# UNITED STATES PATENT AND TRADEMARK OFFICE

APPLICATION NO.	FILING DATE	FIRST NAMED INVENTOR	ATTORNEY DOCKET NO.	CONFIRMATION NO.
10/068,304	02/05/2002	Shoji Hinata	9319S-000323	9656

**Office Action Summary**

**Fig. 7**

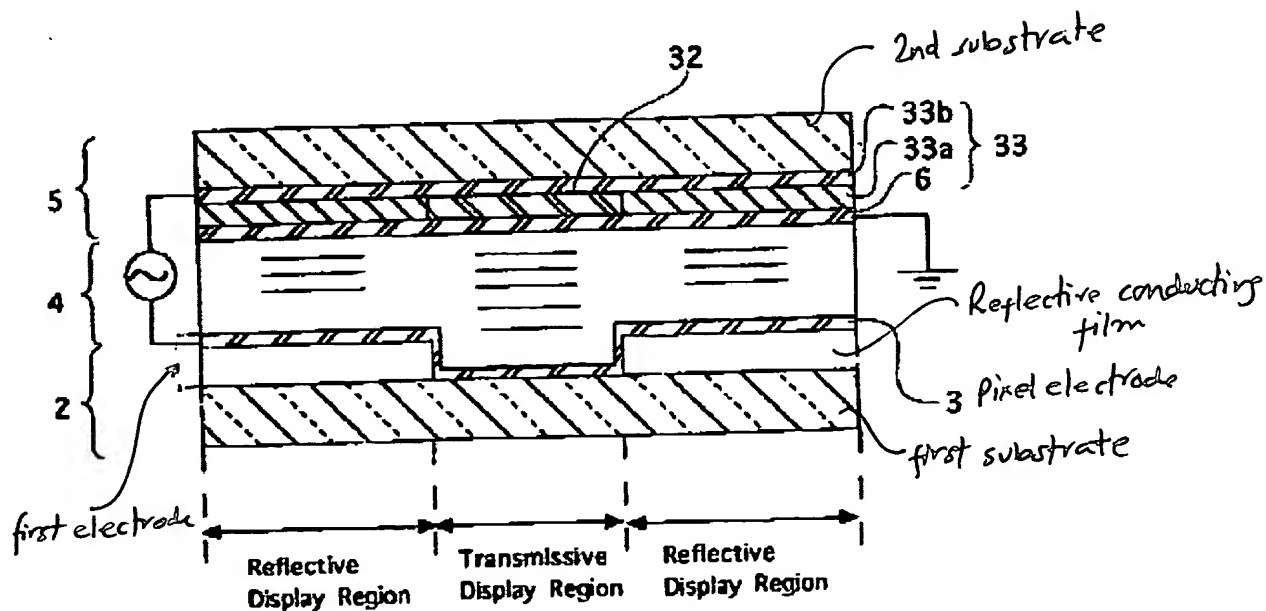
7. Kubota discloses and shows in Fig. 7, a transfective liquid crystal display device comprising:

- a liquid crystal arranged between first and second substrates;

- a reflective conductive film formed on the first substrate;
- a pixel electrode (3) (applicant's light transmitting metal oxide film) (page 4, paragraph 0055) conductive film so that the edge of the metal oxide film is in contact with the first substrate; and
- a light source (applicant's illumination means) irradiating the liquid crystal with light from outside the first substrate (not shown) (page 8, paragraph 0106).

Accordingly, claims 1 and 3 are anticipated.

As to claim 7, Kubota also shows in Fig. 7 that the reflective conductive film and the metal oxide form a first electrode for applying voltage to the liquid crystal layer.

As to claim 8, Kubota also shows in Fig. 7 that the device further comprising a second electrode (6) formed on the second substrate opposite to the first electrode, and a color layer (33a) provided corresponding to the crossing regions between the first and second electrodes.

As to claim 14, it is clear from Fig. 7 of Kubota that the area of the edge in contact with the first substrate is between 10-70%, preferably 30 to 50% of the area of one display dot to which the edge belongs.

Fig. 8

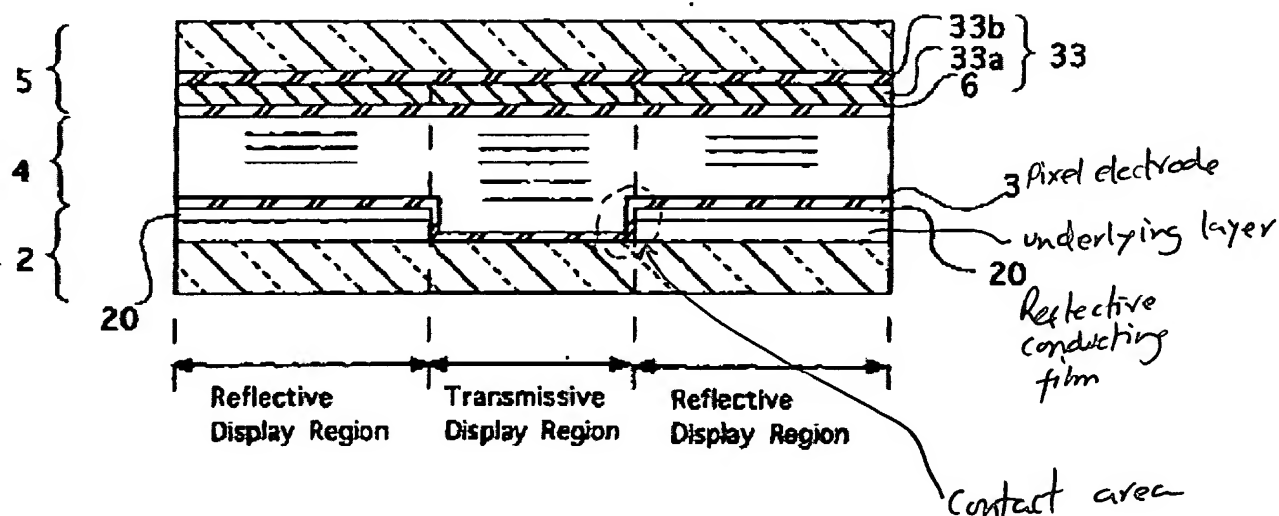
As to claim 2, Kubota shows in Fig 8, a transfective liquid crystal display device comprising:

- a liquid crystal arranged between first and second substrates;

- an underlying layer provided on the first substrate;
- a reflective conductive film (20) formed on the underlying film;

- a pixel electrode (3) (applicant's light-transmitting metal oxide) film laminated on the reflective conductive film (20) so that the edge of the metal oxide film (3) is in contact with the underlying film; and
- a light source (applicant's illumination means) for irradiating the liquid crystal with light from outside the first substrate (not shown).

Accordingly, claims 2 and 4 are anticipated.

As to claim 15, it is clear from Fig. 8 of Kubota that the area of the edge in contact with the first substrate is between 10-70%, of the area of one display dot to which the edge belongs.
